Access Compliance Report
Public Rights-of-Way
(Pedestrian Signals)

Intersection ID: N/A	Main Street:	Cross Street: N/A	Location: N/A

ADA ID: 0C596E98A952   **Signal Type:** One Push Button-APS   **Overall Compliance:** No   **Severity Score: BTN 1:** N/A   **BTN 2:** N/A   **No BTN:** N/A

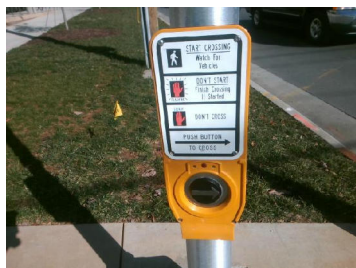
PROW/ADA: TMUTCD 4e.08, R404.2, R404.3, R209.1, MUTCD 4e.10

Possible Solutions: Replace Signal Push Button With APS Button on New Post. Remove & Relocate Sign.
